2.6 Nuclear Steam Generation System

The HTR two-module plant is designed as a double-block facility with two reactors, each with 200 MW thermal capacities. Therefore, two nuclear steam generating systems, each independent of the other, have been provided and share some auxiliary installations.

Figure 2.6.1: HTR pressure vessel unit (RDB+DE+connecting pressure vessel) under internal pressure

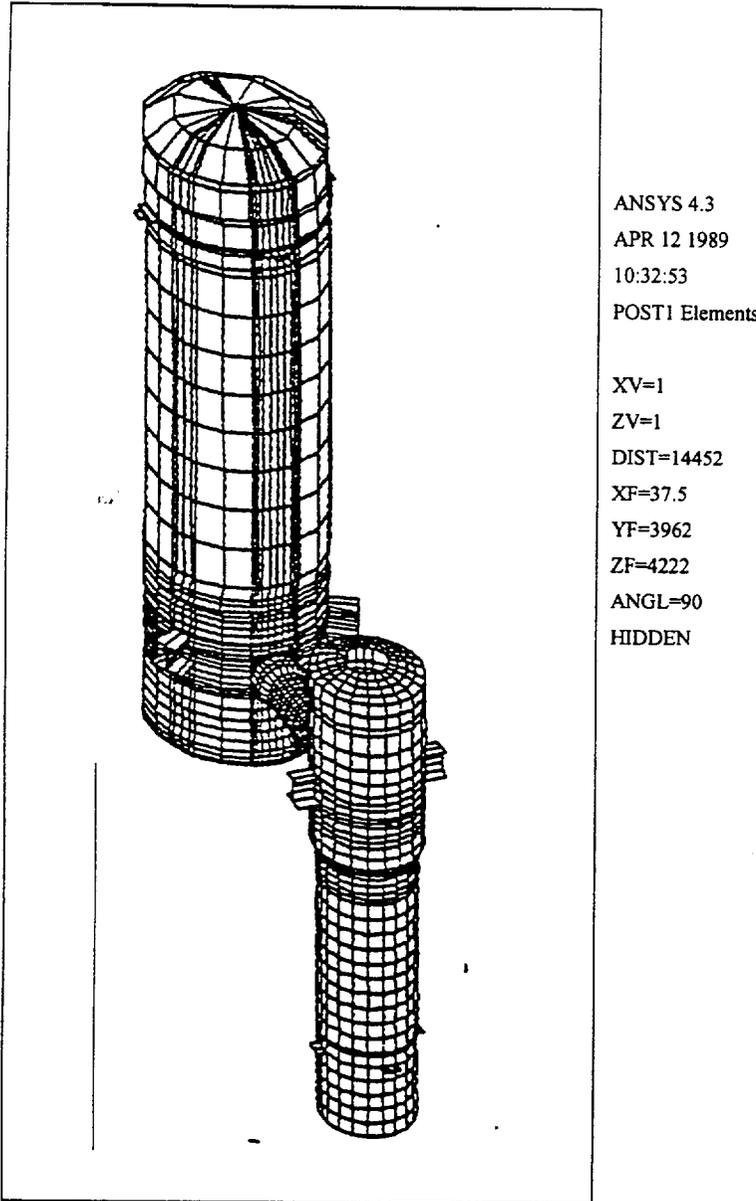
Within the framework of the design phase, no analysis of the mechanical behavior according to KTA Rule 3201.2 was carried out by the applicant. However, to evaluate the mutual influence of temperature, pressure and obstructed thermal expansion on different vessel units, we have designed the entire pressure vessel unit as a finite element model and calculated the various load types (Figure 2.6-1).
